SUBJECT: ST. LUCIE UNIT 2 - ISSUANCE OF AMENDMENT REGARDING PRESSURE  
TEMPERATURE LIMITS (TAC NO. MA9532)

AMENDMENT TO FACILITY OPERATING LICENSE

Amendment No. 112  
License No. NPF-16

SAFETY EVALUATION BY THE OFFICE OF NUCLEAR REACTOR REGULATION

**FIGURE 3.4-2  
ST. LUCIE-2 P/T LIMITS, 21.7 EFPY  
HEATUP AND CORE CRITICAL**

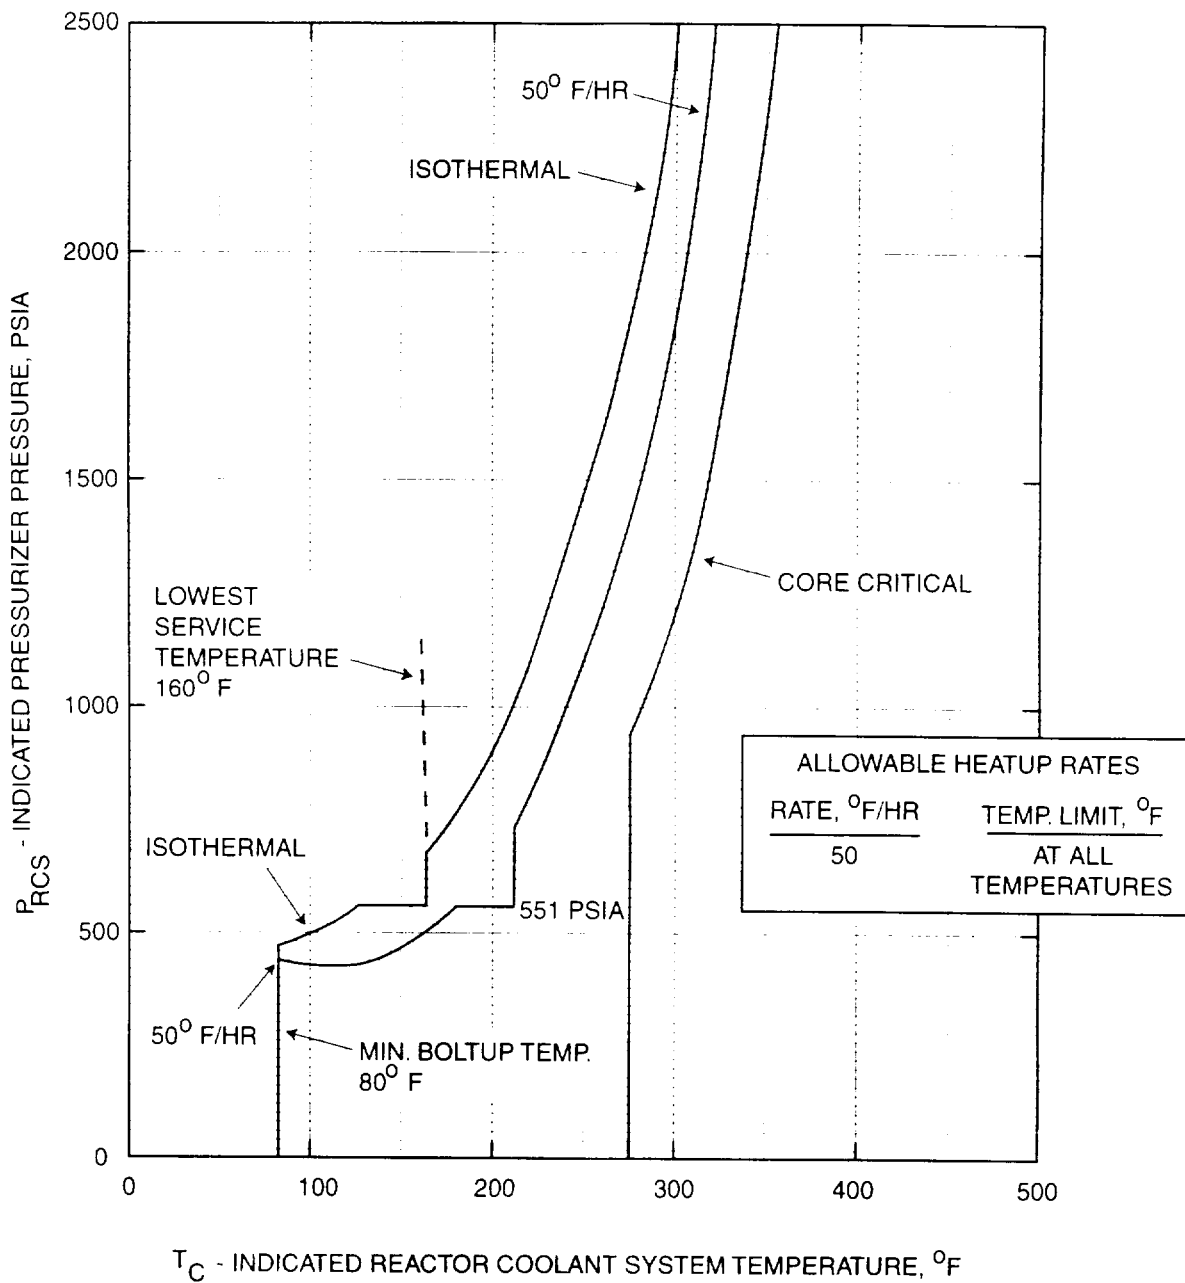
The U.S. Nuclear Regulatory Commission has issued the enclosed Amendment No.112 to Facility Operating License No. NPF-16 for the St. Lucie Plant, Unit No. 2. This amendment consists of changes to the Technical Specifications in response to your application dated July 19, 2000. It will extend the applicability of the current reactor coolant system pressure/temperature limits and allowed heatup and cooldown rates to 21.7 effective full power years of operation.

By letter dated July 19, 2000, Florida Power and Light Company, the licensee, submitted a Technical Specifications (TSs) change request to revise the pressure temperature (P-T) limits for St. Lucie Unit 2. The proposed change involves the revision of the specified effective full power years (EFPY) from 15 EFPY to 21.7 EFPY, while keeping the current P-T limits unchanged. The P-T limits calculations are based on the 1989 American Society of Mechanical Engineers (ASME) Appendix G methodology.

The heatup and cooldown limit curves Figures 3.4-2, 3.4-3 and 3.4-4 are composite curves which were prepared by determining the most conservative case, with either the inside or outside wall controlling, for any heatup rate of up to 50 degrees F per hour or cooldown rate of up to 100 degrees F per hour. The heatup and cooldown curves were prepared based upon the most limiting value of the predicted adjusted reference temperature at 21.7 EFPY, and they include adjustments for pressure differences between the reactor vessel beltline and pressurizer instrument taps.

The reactor vessel materials have been tested to determine their initial  $RT_{NDT}$ ; the results of these tests are shown in Table B 3/4.4-1. Reactor operation and resultant fast neutron (E greater than 1 MeV) irradiation will cause an increase in the  $RT_{NDT}$ . An adjusted reference temperature can be predicated using a) the initial  $RT_{NDT}$ , b) the fluence (E greater than 1 MeV), including appropriate adjustments for neutron attenuation and neutron energy spectrum variations through the wall thickness, c) the copper and nickel contents of the material, and d) the transition temperature shift as recommended by Regulatory Guide 1.99, Revision 2, "Effects of Residual Elements on Predicted Radiation Damage to Reactor Vessel Materials," or other approved method. The heatup and cooldown limit curves Figures 3.4-2, 3.4-3 and 3.4-4 include predicted adjustments for this shift in  $RT_{NDT}$  at 21.7 EFPY.

The staff finds the extension of the EFPY from 15 EFPY to 21.7 EFPY to be acceptable because the current pressure temperature curves were evaluated for the fluence value to be attained at the end of the 21.7 EFPYs. The staff has also determined that the proposed P-T limits for the reactor coolant system for heatup, cooldown, hydrotest, and criticality satisfy the
